APPENDIX J

HAZARDOUS, TOXIC AND RADIOLOGICAL WASTE (HTRW)

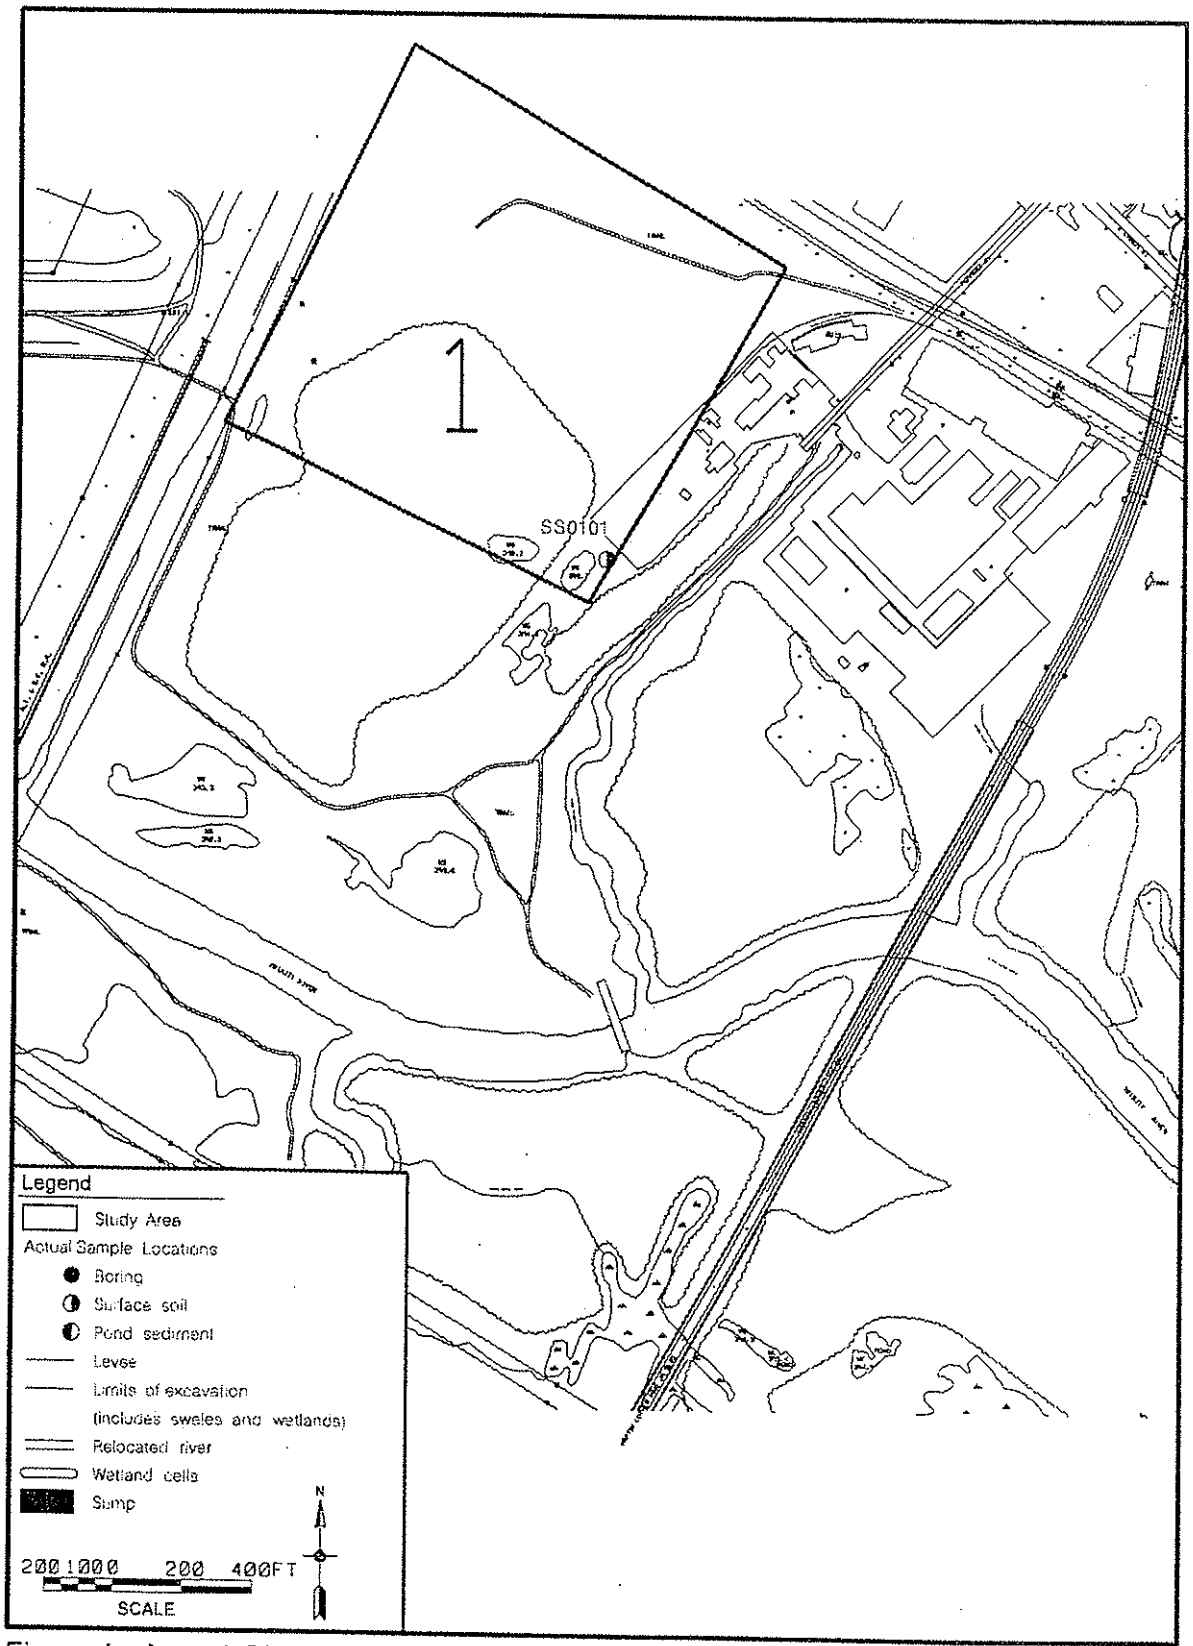
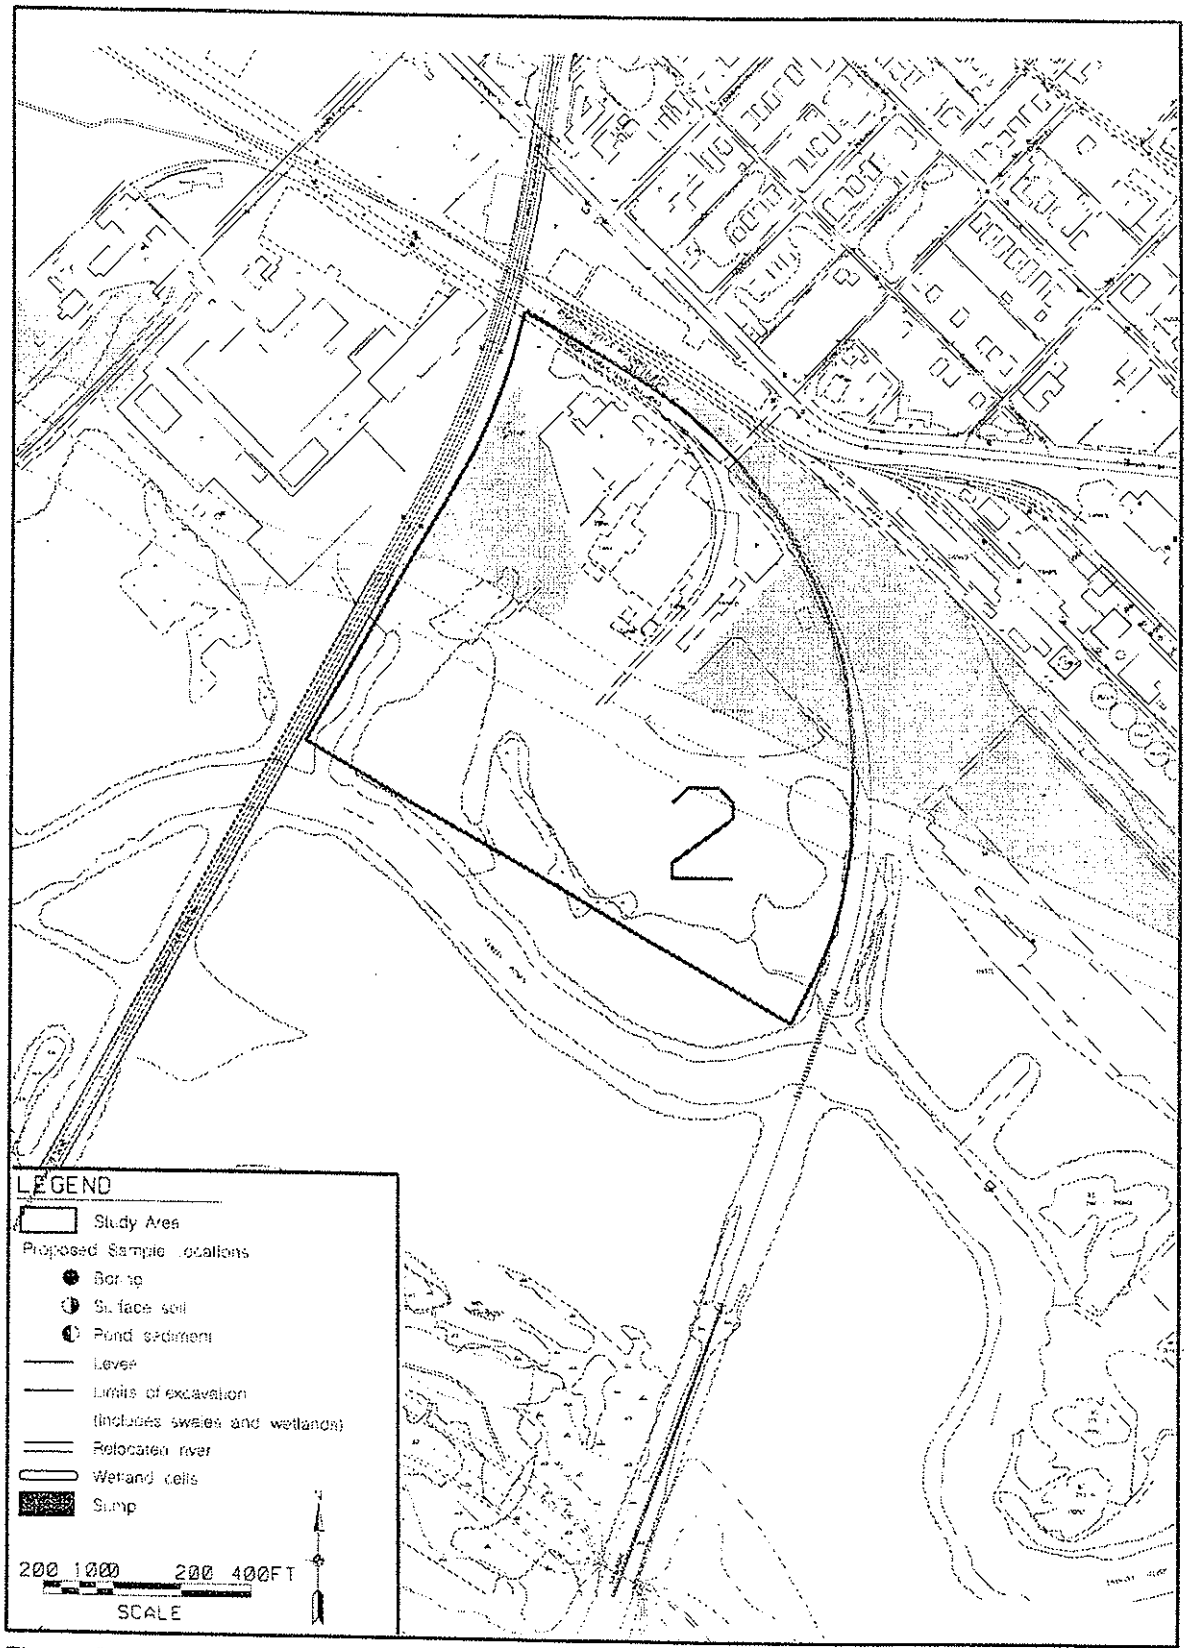
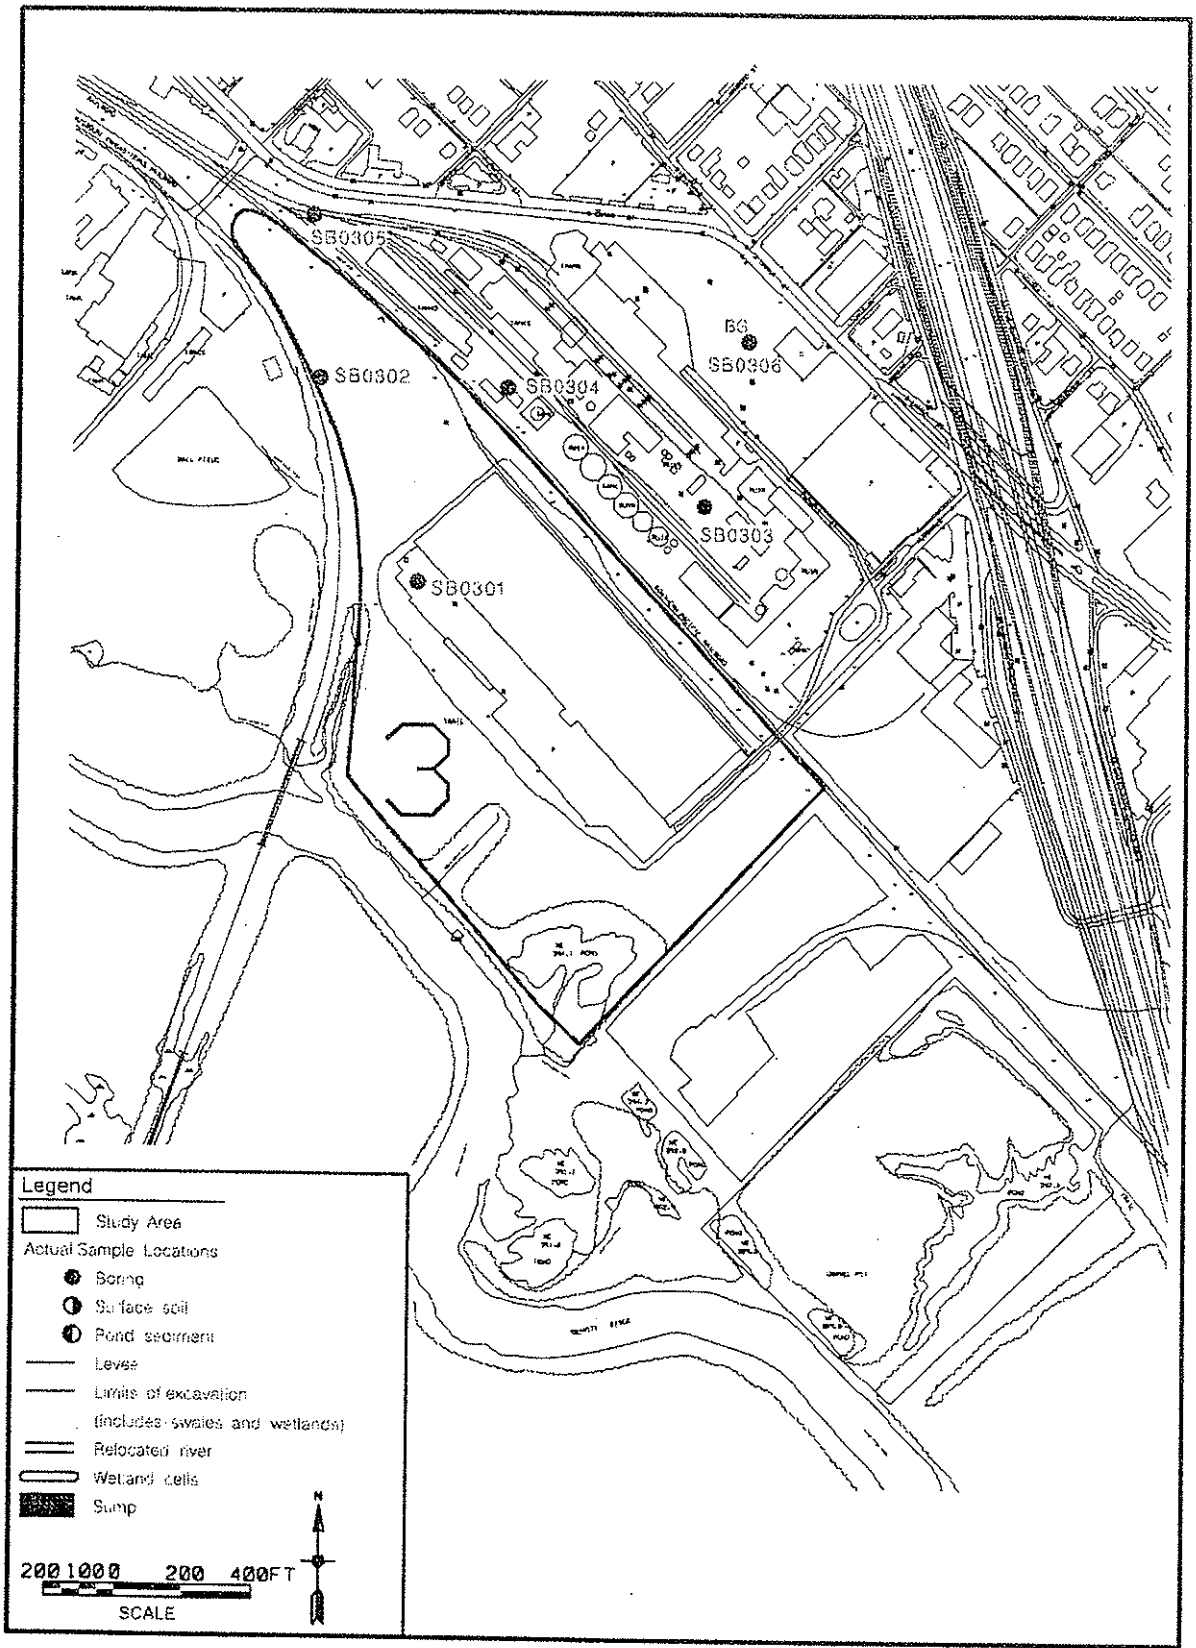
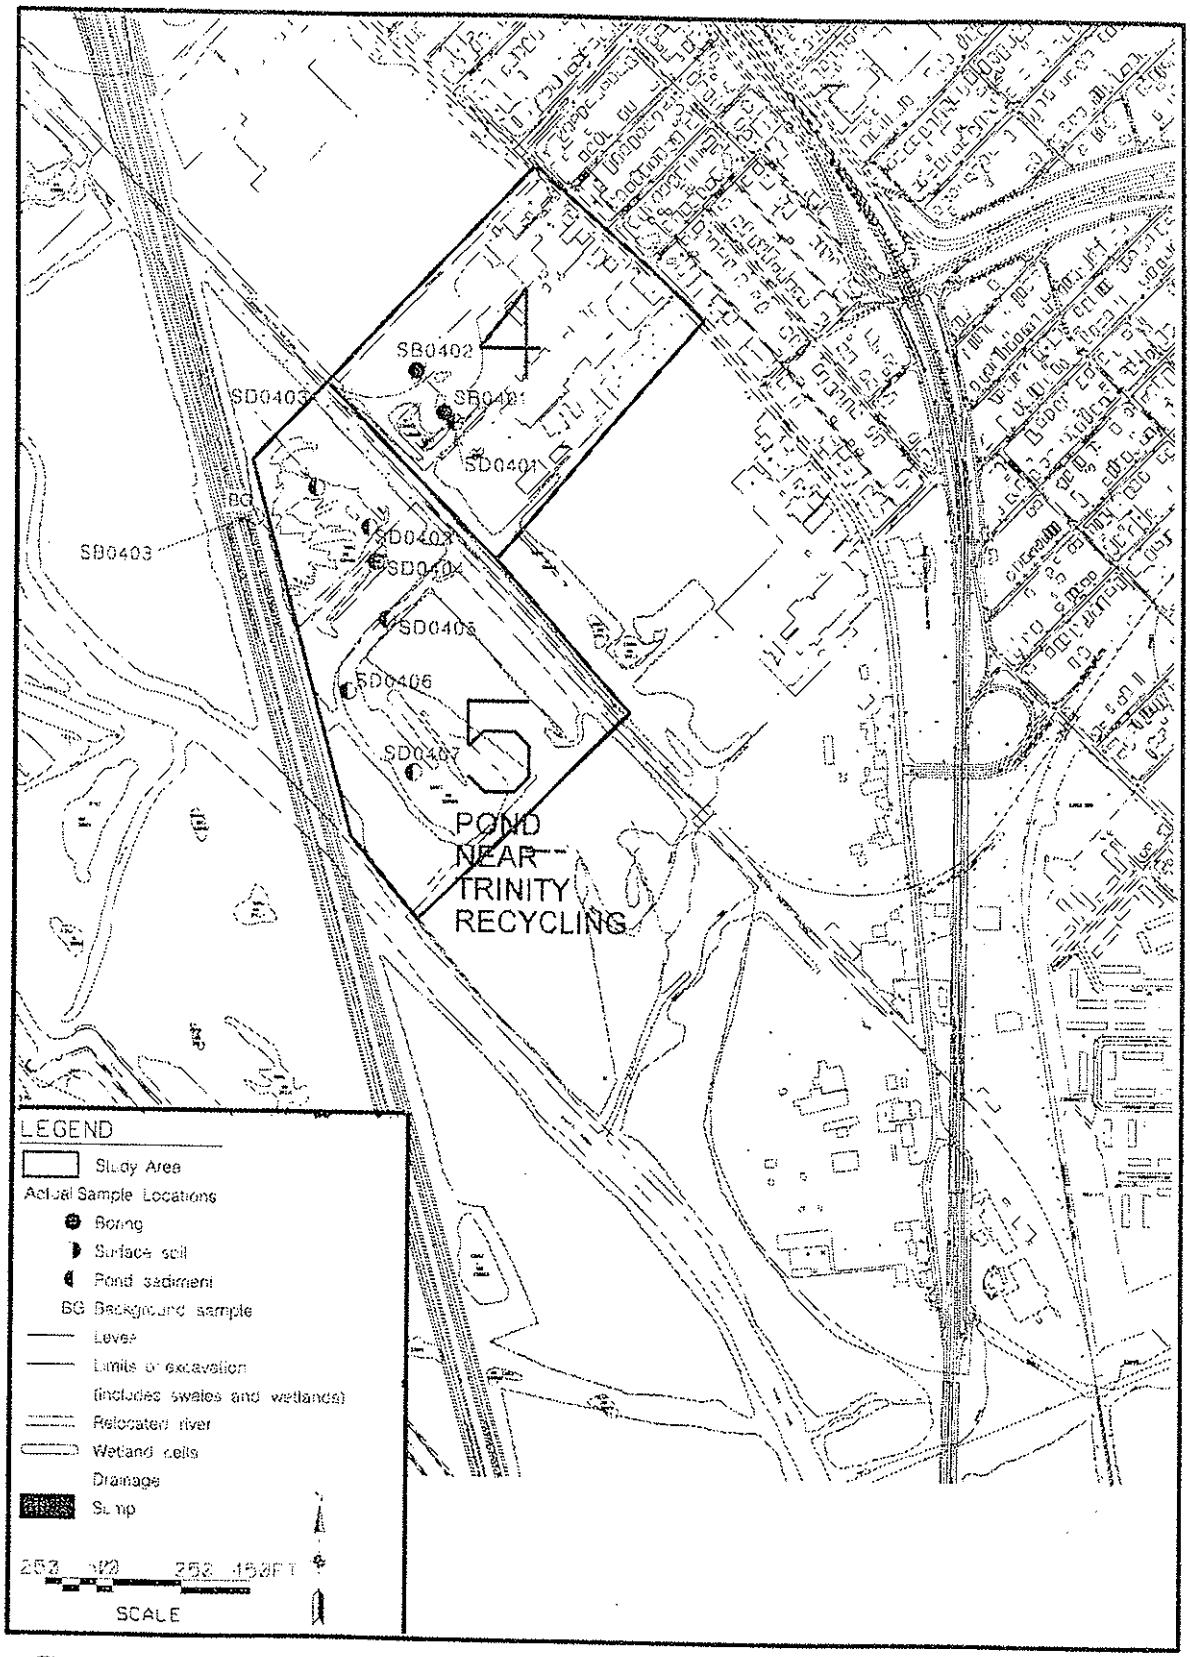
186. Appendix J, Figure 1 Area 1 through Figure 11 Area 13 are not clear and do not adequately show locations and addresses of borings made. The figures do not show borings taken from surface soil, swales, COWs, levees, sumps.

183. The locations of these areas are shown in figure 1, immediately prior to Section J-1, and in Section J-1 of Appendix J.
